Scheme Wide Drainage Strategy Report - Project number: 60606782

The report provides an initial high level basis for development into detailed design. Initial comments are noted in the below against the relevant sections, in *italics*.

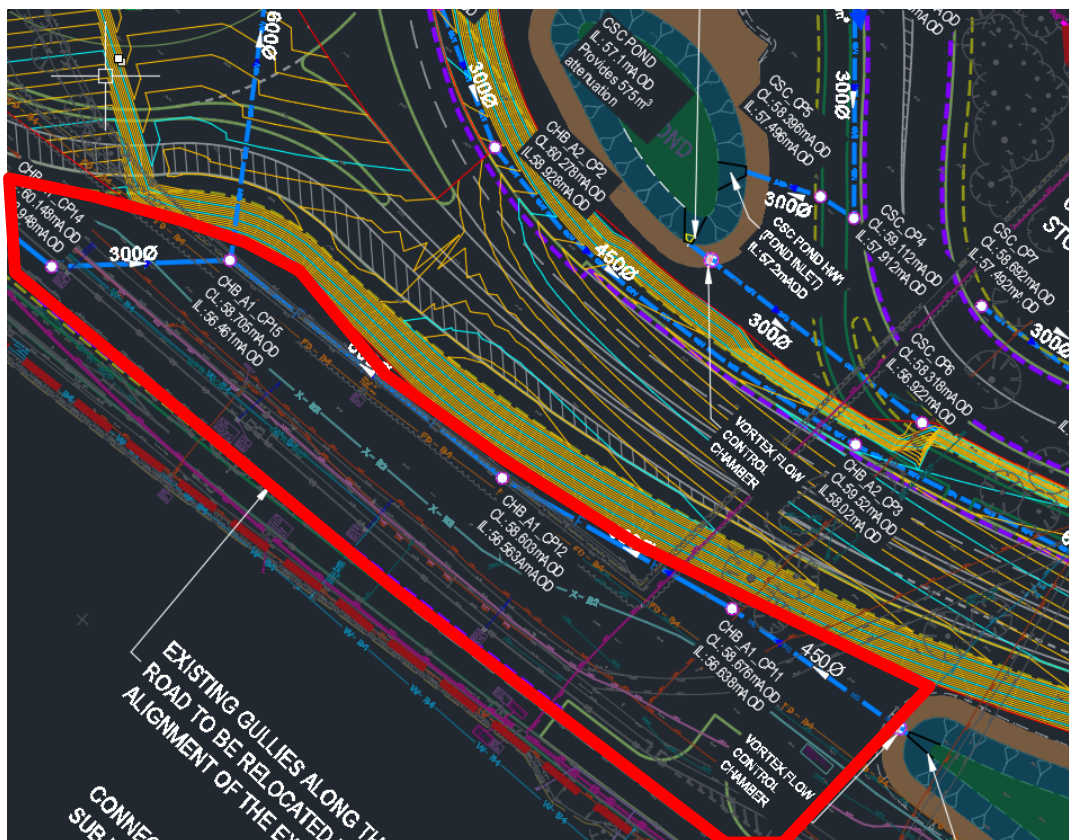
4.4.4 These flows will not be connected into the highway drainage system or the ponds except the locations between chainages CH200 and CH570 to the south of the CHB (see drawing CHB_PD-ACM-HDG-SW_ZZ_ZZ_ZZ-DR-CD-0001) and between chainages CH1300 and CH1700 (see drawing CHB_PD-ACM-HDG-SW_ZZ_ZZ_ZZDR-CD-0002) to the north of the Clifton Hampden Bypass between Farm Access and west of the CSC Secondary Access.

4.4.5 The flow from the natural catchment between chainages CH200 and CH570 will be connected to the highway drainage system due to the ground falling from east to west. There is no feasible solution to separate the overland from the highway drainage as this area is constrained by the existing utilities.

4.4.6 The flow from the natural catchment between chainages CH1300 and CH1700 will

be collected in ditches and then will be connected to the highway drainage system due to the ground falling from east to west. There is no feasible solution to separate the overland from the highway drainage as this area is located in close proximity to the Culham Science Centre boundary and therefore it is constrained by the Red Line Boundary.

Cannot have overland surface water flow paths intercepted then directed into highways drainage network – no mixing surface water/highways drainage.

This approach will need agreement, if permissible with OCC HA.

AECOM Response –
Catchment A and roundabout – Overland runoff (highlighted in red)

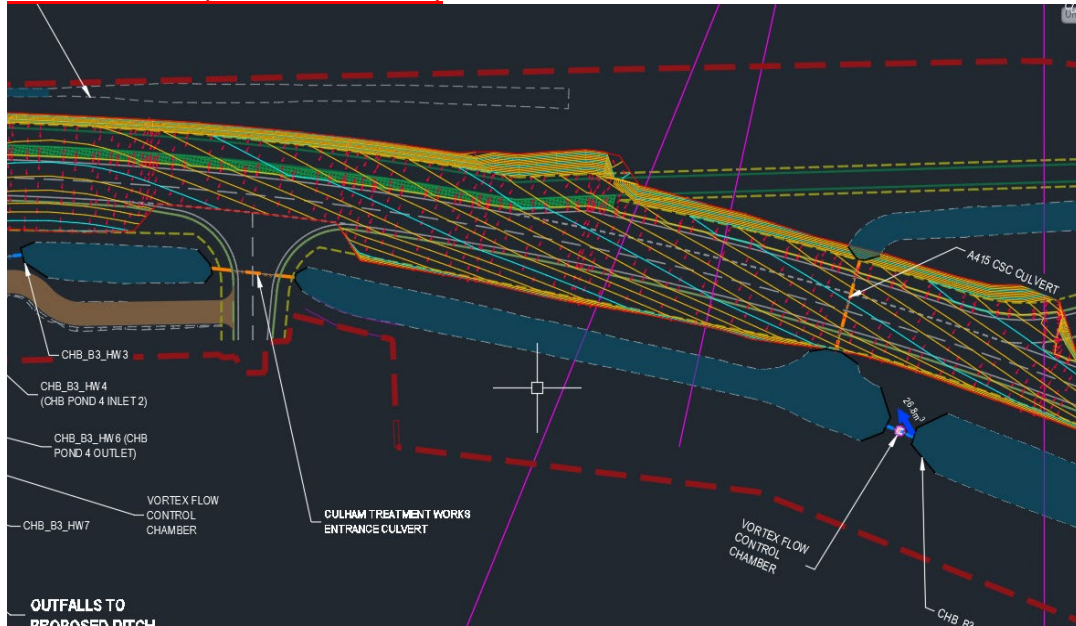
4.4.7 There is another small area of natural catchment on either side of the realigned B4015 which will be also be connected to the highway drainage due to insufficient space to provide separate open ditches to collect the surface water runoff from the natural catchment.

This will need further justification why the natural drainage regime of the catchment cannot be replicated and why there is a need to divert overland surface water flows into a highways drainage network.

Constraints considered during preliminary stage:

Utilities and proposed road EW extents. Therefore, no space is available to provide separate ditch to convey the overland runoff.

Solution to separate the overland from highway: Connect 600mm pipe from CHB_A1_CP16 directly to the CH_A1_CP18 (existing SW sewer). This will have a cost implication by adding additional 100m long (approximate) 600mm carrier pipe and an additional MH (1.5m dia).
